Omaha Public Power District

July 2, 1981

The Commission's letter dated May 13, 1981, forwarded questions regarding the adequacy of Fort Calhoun Station's electrical distribution system voltages. Omaha Public Power District's response to those questions are attached.

TRANSFORMER TAP CHANGE
DESIGN DESCRIPTION

Motor Terminal Voltage
CalculationsSH 2 CONT ON SH 3OMAHA PUBLIC POWER DISTRICT
GENERATING STA ENG

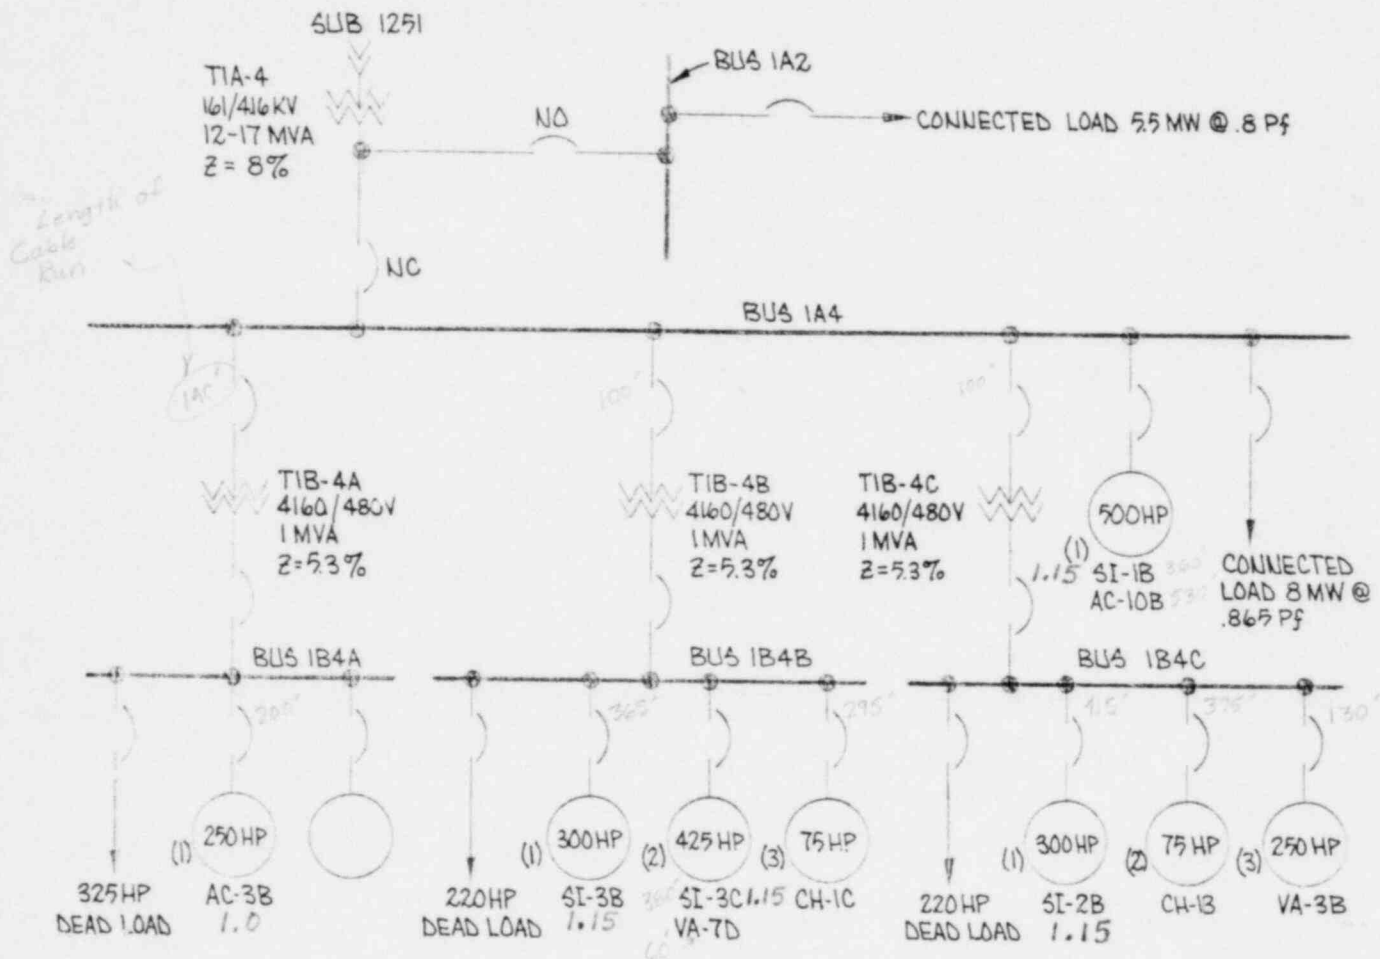
- (B) The voltages at buses 1A3 and 1A4 in Tables 1, 2, and 3 of attachment 5 appear to be based on transformers T1A3 and T1A4 set on the 165kV tap (see sheet 2). What will the voltages be at buses 1A3 and 1A4 in Tables 1, 2, and 3 if the transformers are on the 161kV tap?

- (D) What is the service factor for the 4160V, 4000V, and the 460V safeguards motors?

Some load flows were run to examine the effect of changing the taps on the house service transformers at Fort Calhoun from 165 kV to 161 kV. Of primary interest is the power flowing through the generator auxiliary transformer when its secondary is tied to the secondary of the house service transformer. This is a condition that exists momentarily during the normal transfer of station service loads between the 161 kV and the 22 kV sources. Buses 1A2 and 1A4 were used in this analysis because they are more heavily loaded than buses 1A1 and 1A3. Enclosure 2, column V1A2, V1A4, demonstrates this effect.

Enclosure 3 provides a partial listing of motor service factors. Additional investigation is required for the remaining motors and this information will be provided by August 15, 1981.

Service Factors in green.
